UNITED STATES PATENT AND TRADEMARK OFFICE

APPLICATION NO.	FILING DATE	FIRST NAMED INVENTOR	ATTORNEY DOCKET NO.	CONFIRMATION NO.
10/756,877	01/13/2004	Lon Richard Buske	10331.1/40176.64USC1	3429

Office Action Summary

FIG. 2

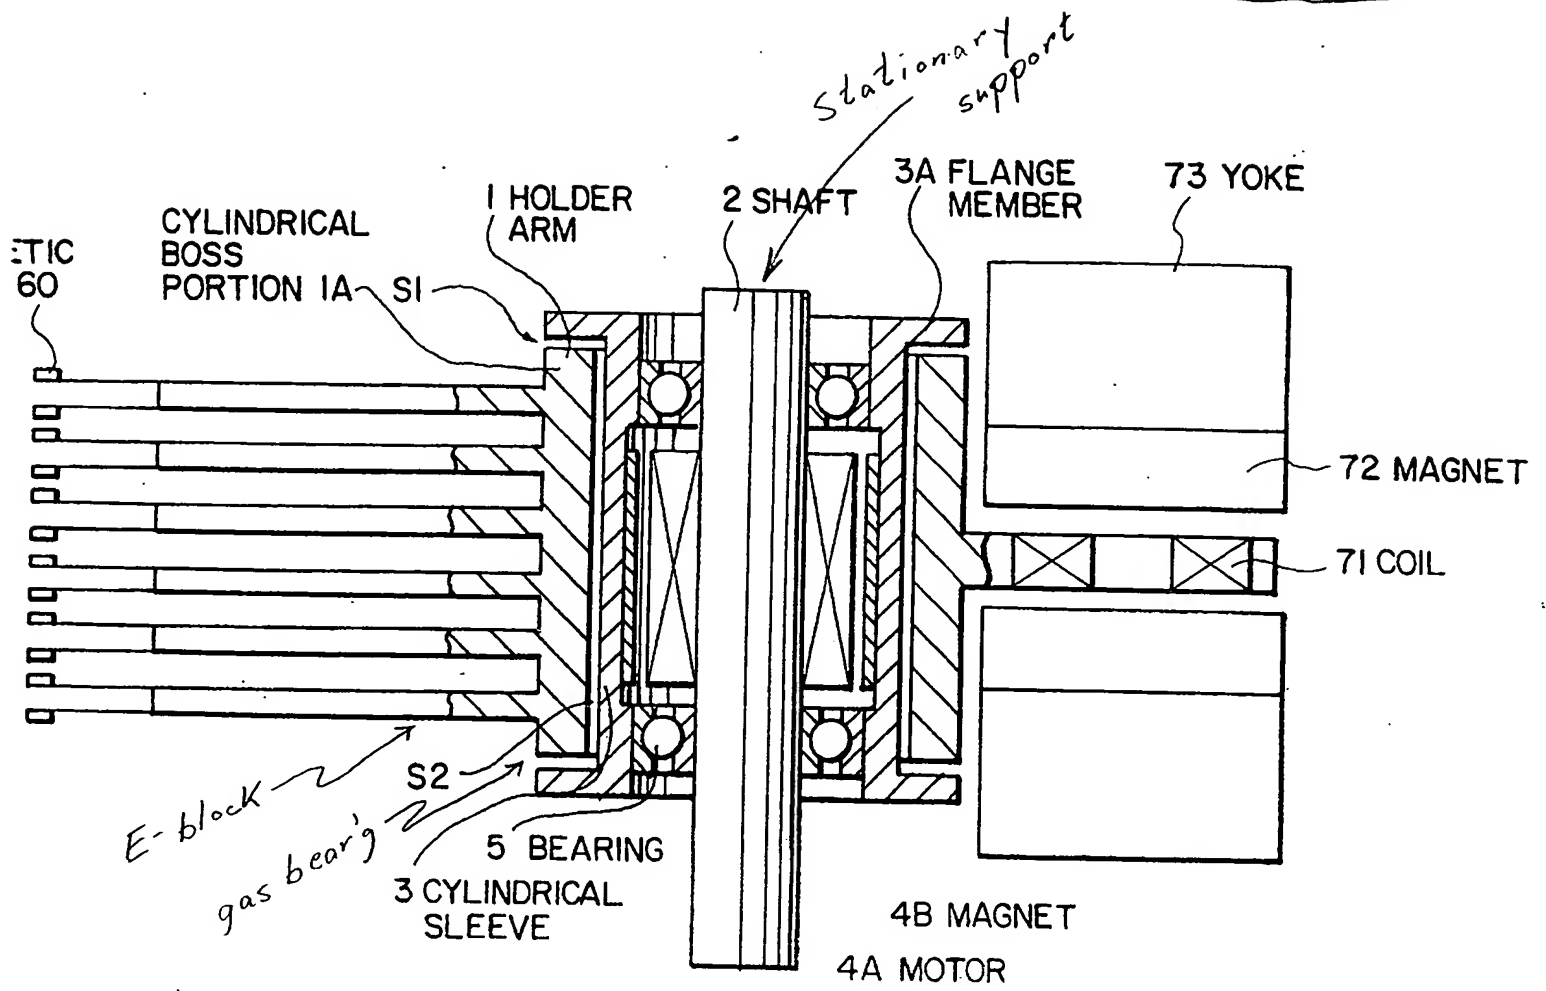
5. Claims 10-12 are rejected under 35 U.S.C. §102(b) as being anticipated by Sanada.

See Fig. 2. Note, to the extent claimed and understood, the structure as shown in Addendum A reads on and performs to the same degree as claimed; e.g. the claimed invention fails to enunciate any structural distinction which is more 'vibrationless' than that shown in Sanada.
